CS Memorandum No. 1331

Subject: Configuration Management Board Meeting No. 108

CMB Meeting Minutes #108

SUBJECT: Configuration Management Board Meeting # 108 – Rev. No. 0

Sta. 164+74, Panel P-10

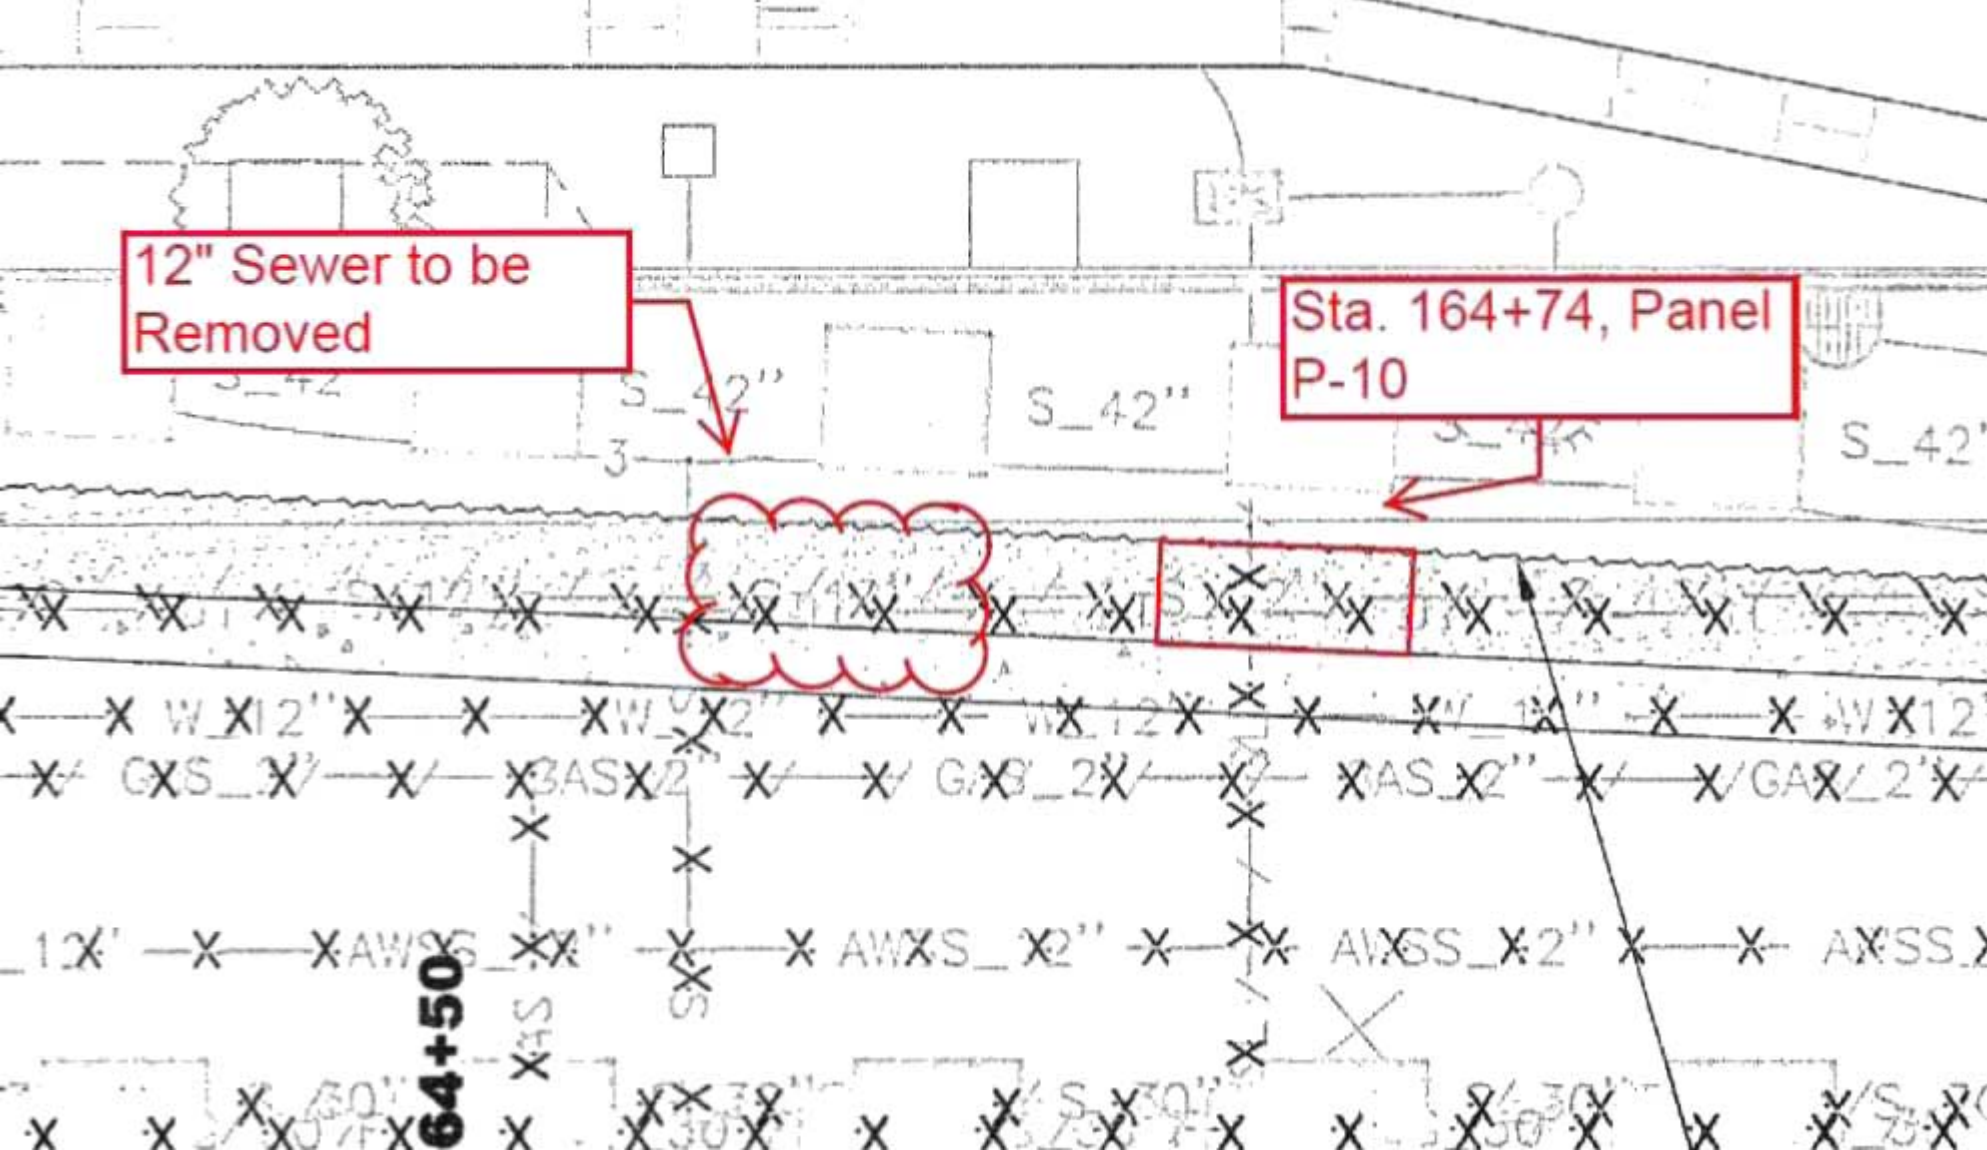
5-	1252 – S. Wilson presented Evaluation of Merit of, COR 067 – LB – Panel P-10 Buried Obstruction - Contractor encountered concrete encased 12in clay sewer pipe with slurry wall panel P-10 at the TBM Launch box 7 feet below the top of the SW guidewall. Concrete encasement is not shown on the drawings. The encasement prevented SW construction from occurring as originally planned The CMB did not agree with merit requesting the evaluation of merit be rewritten to address time impact, if any In addition the CMB suggested the RE should include the inspector's daily tags as backup or reference the tag numbers in the write-up when force account work is involved. <i>This item will be brought back to the CMB.</i>	S. Wilson 01/09/13
6-	The Project Trend/Change Control Log update thru 12/19/12 was reviewed. The CMB requested that final contract cost information for contracts 1250 Utilities Relocation and 1251 UMS Utilities be cross checked and correlated with Board memos written to close are reflected in the logs summary.

Contractor Rationale for COR: The contract does not indicate the presence of the concrete encasement within the footprint of SW panel P-10. The concrete encasement has prevented SW construction from occurring as originally planned.

Justification: RE has evaluated the conditions outlined in Article 3.04 and found that: conditions differ materially and conditions will cause scope of work to increase.
